### Utility Map

July 21, 2016

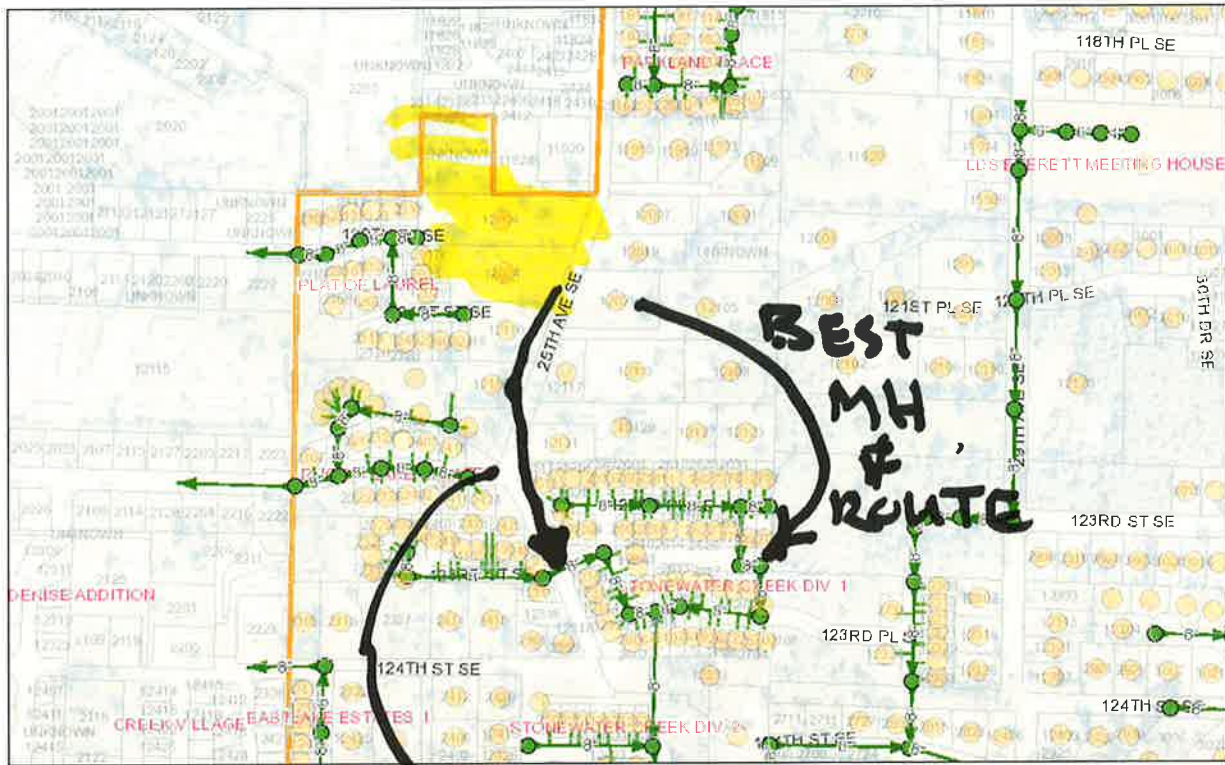
staying in 25th  
may work  
Need actual survey  
to confirm

The sewer to the west of your site  
are shallow & would probably only  
serve part of your property as  
25th Ave is lower than your property
